**Federal Highway
Administration**

Refer to: HNG-14

Your November 6 letter to Mr. William A. Weseman provided videotape and test reports indicating that the Slotted Rail Terminal (SRT) successfully met the National Cooperative Highway Research Program (NCHRP) Report 350 evaluation criteria as a test level 3 (TL-3) guardrail terminal. This letter also requested the Federal Highway Administration's (FHWA) concurrence in this determination.

100 KM/H SLOTTED RAIL TERMINAL.

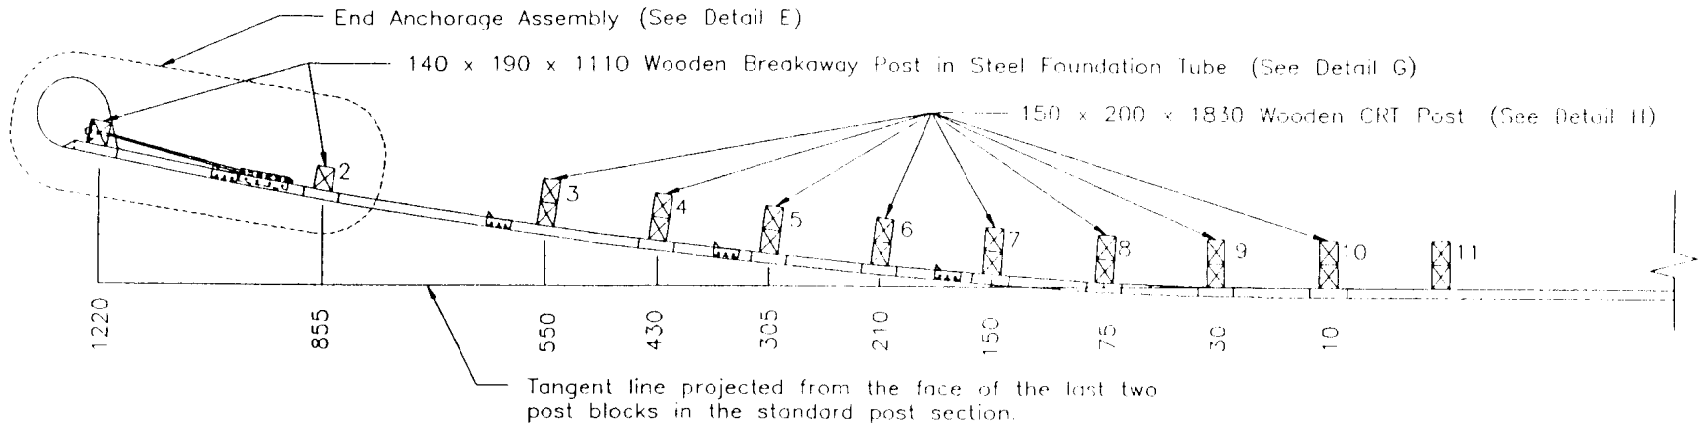
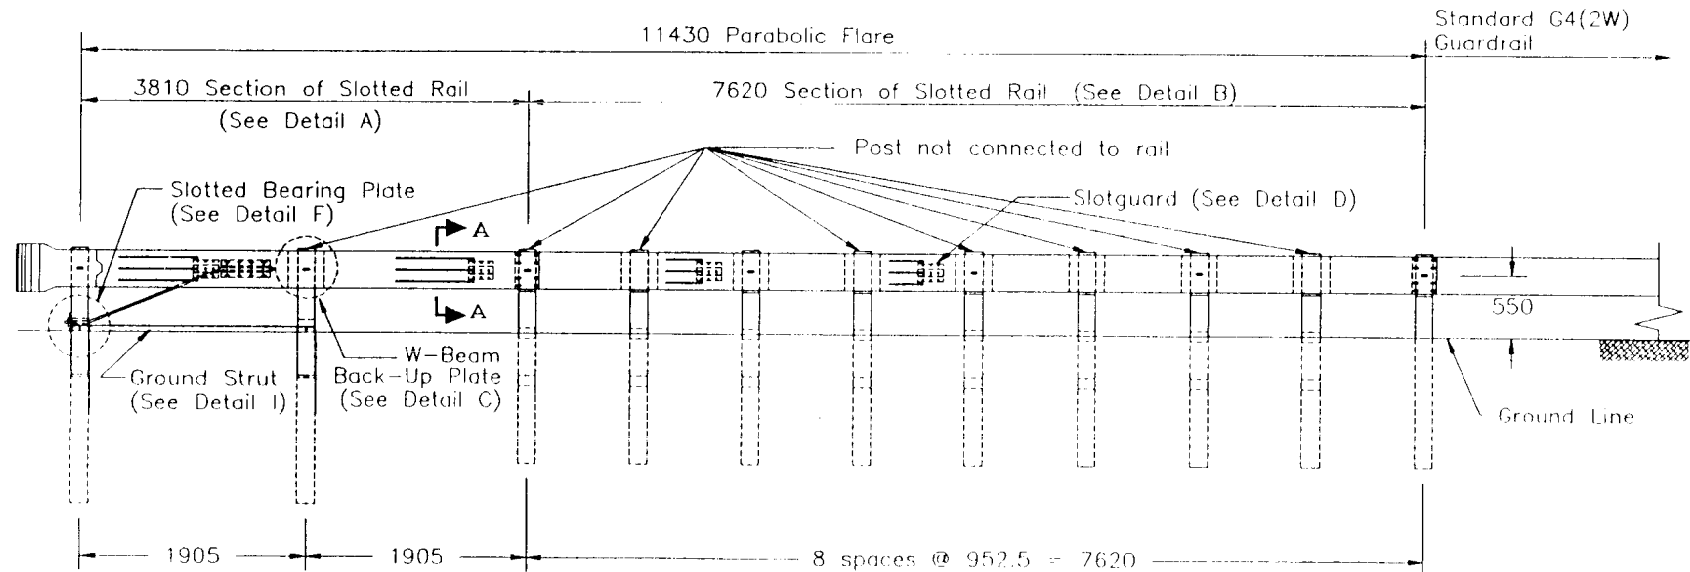
In reviewing this material, we noted that the final NCHRP Report 350 terminal differed from the 230 tested design in the following ways:

1. The 305-mm long slots at post number 2 have been eliminated.
2. The w-beam rail element spanning posts 3 through 11 is a single section 76 20~~0~~ mm in length. The 230 design used two 38 10~~0~~-mm sections of w-beam in this area.
3. In lieu of a shelf angle to hold the rail in place, the 350 design uses standard 305-mm long w-beam backup plates at post 2 and at posts 4 through 10.
4. The 350 design uses a total of eight CRT posts (posts 3 through 10).

As with all gating terminals, the SRT must be installed on a relatively level site and have a reasonably clear and traversable area behind it for optimal performance in the field. We assume that, as with the BCT and the MELT terminals, the barrier length of need begins at post number 3 for the SRT.

The FHWA concurs that the SRT is an acceptable TL-3 terminal for strong-post w-beam barrier and may be used on projects on the National Highway System when selected by a State highway agency.
